DART SERVICE INSTRUCTION

TO AMEND INSTALLATION INSTRUCTIONS IIN-D350-689 REV. A

INSTALLATION OF D350-689-013 FLOOR PROVISION KIT ON AIRCRAFT EQUIPPED WITH SLIDING DOORS

VIEW A

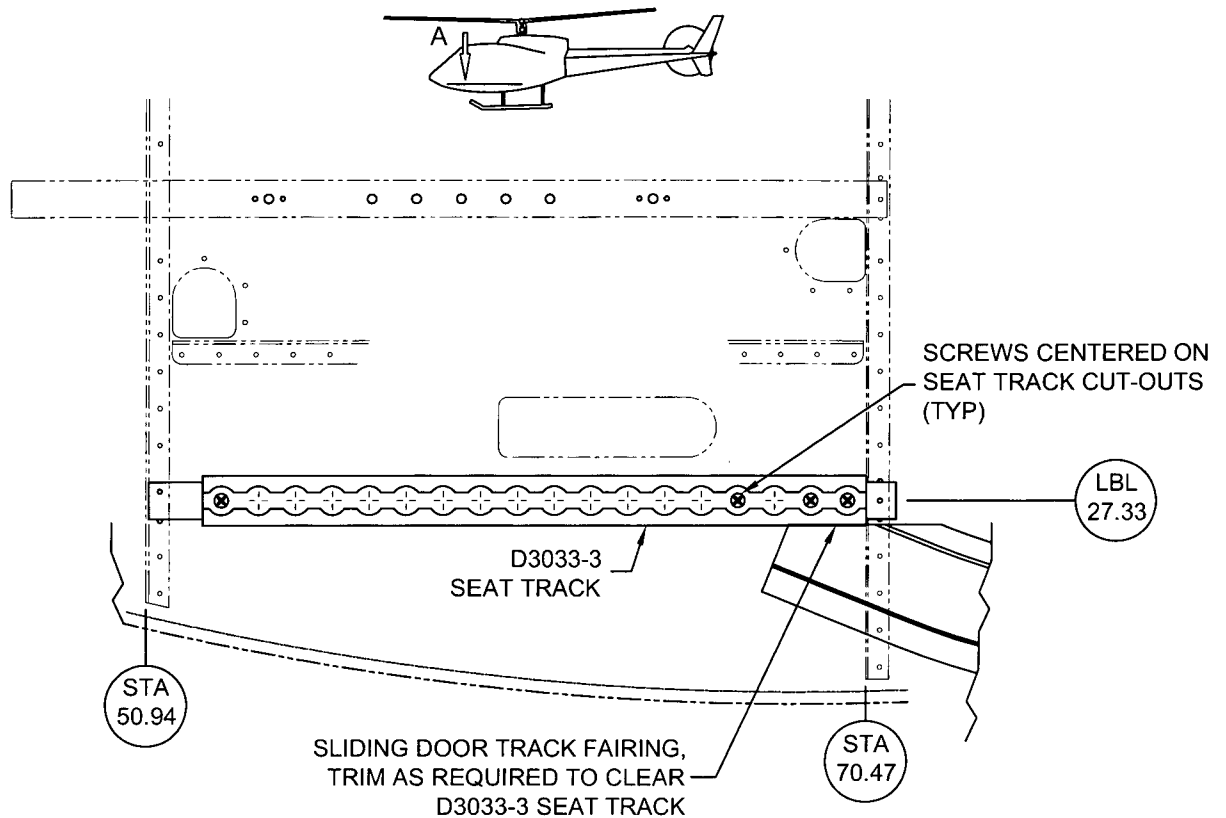
IN ORDER TO FACILITATE INSTALLATION OF THE D350-689-013 FLOOR PROVISION KIT ON AIRCRAFT EQUIPPED WITH SLIDING DOORS, TRIM THE SLIDING DOOR TRACK FAIRING AS REQUIRED TO CLEAR THE D3033-3 SEAT TRACK AS SHOWN BELOW. COMPLETE REMAINDER OF INSTALLATION AS DESCRIBED IN INSTALLATION INSTRUCTIONS IIN-D350-689.
